January 22, 2008

**National Park Service**  
**Comments on the Ely Energy Center Power Plant**  
**Prevention of Significant Deterioration Permit Application**  
**January 23, 2008**

Figure 1. Ely Energy Center vs. IGCC Comparisons

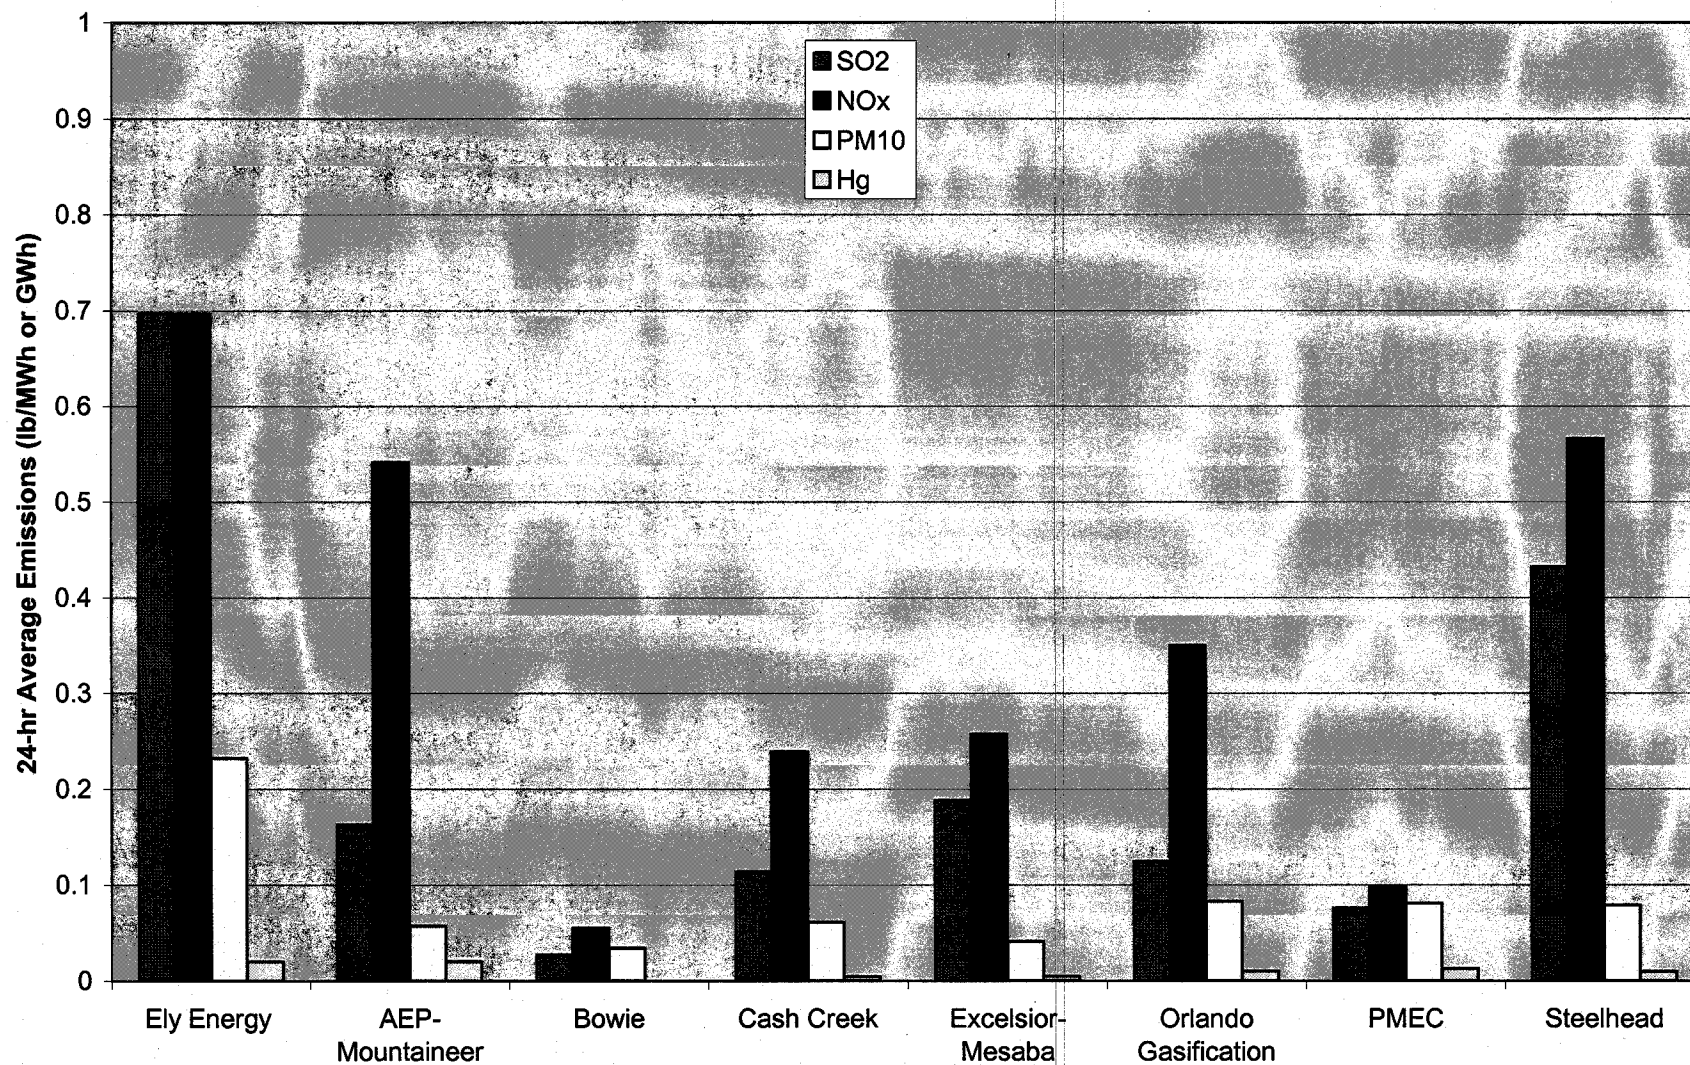
We have received applications for seven proposed IGCC facilities<sup>7</sup> and their relative emissions (in terms of lb/MWh<sub>net</sub> for SO<sub>2</sub>, NO<sub>x</sub>, and filterable PM<sub>10</sub> and in lb/GWh<sub>net</sub> for mercury) are shown in Figure 1 (attached) along with EEC. It is clear that IGCC is a cleaner coal-to-energy technology than the conventional PC boiler technology proposed by SPR.

In summation, while a state is not required to consider IGCC, it may do so, as has been demonstrated by New Mexico in its evaluation of the Mustang power plant, and by Illinois regarding the Indeck-Elwood project. All things considered, we believe it is time for new power generators to take a serious look at the sorts of “clean coal technologies” being promoted by our administration as it seeks to relieve our dependence upon foreign energy sources while protecting our environment. We also believe that the benefits of IGCC outweigh its costs and that IGCC is a leading candidate for that role, and should be considered by EEC. Since facilities such as EEC will likely be operating for the next 60 years or more, we believe Nevada Division of Environmental Protection (NDEP) should re-consider and re-evaluate IGCC.

Figure 2. PC Emissions

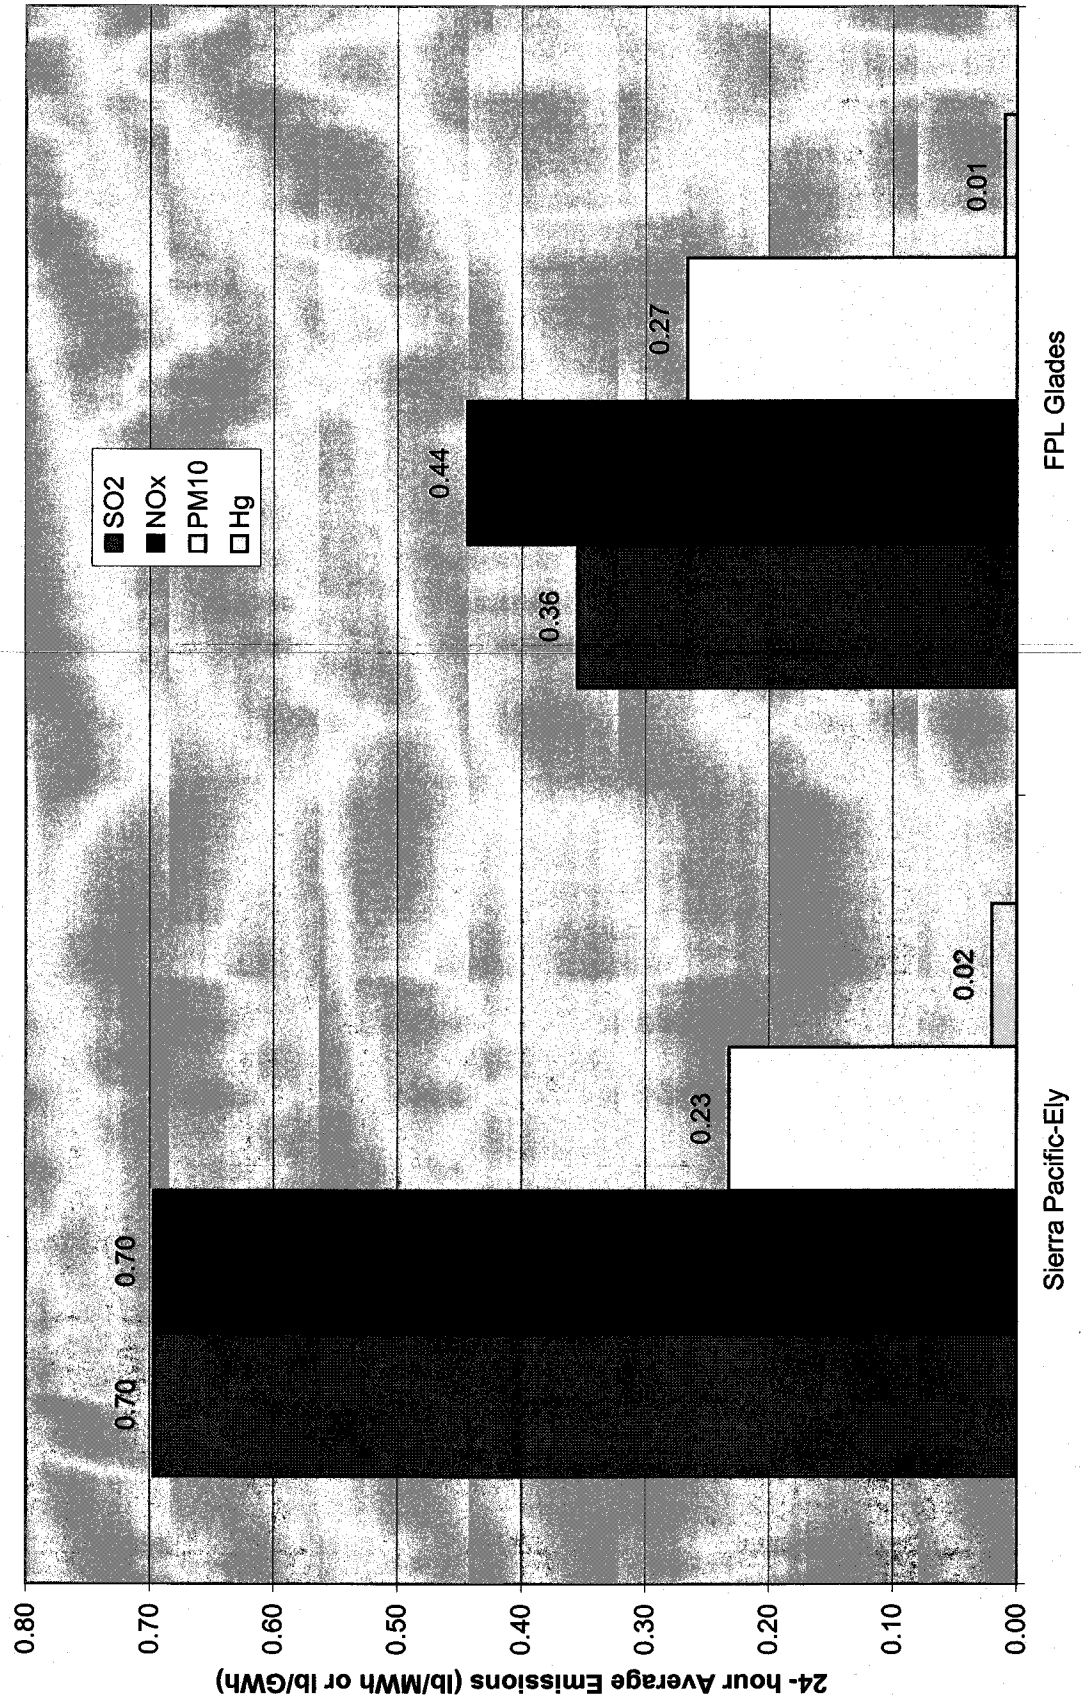
In summary, we believe that further consideration must be given to IGCC "clean coal" combustion technology, and believe that EEC could achieve lower SO<sub>2</sub>, NO<sub>x</sub>, Hg, H<sub>2</sub>SO<sub>4</sub> and PM<sub>10</sub> emission limits by

either choosing an inherently cleaner coal combustion technology or by more effectively using the control technologies chosen for the boiler. Figure 2 (attached) illustrates some of the differences between EEC and the Florida Power & Light Glades project.
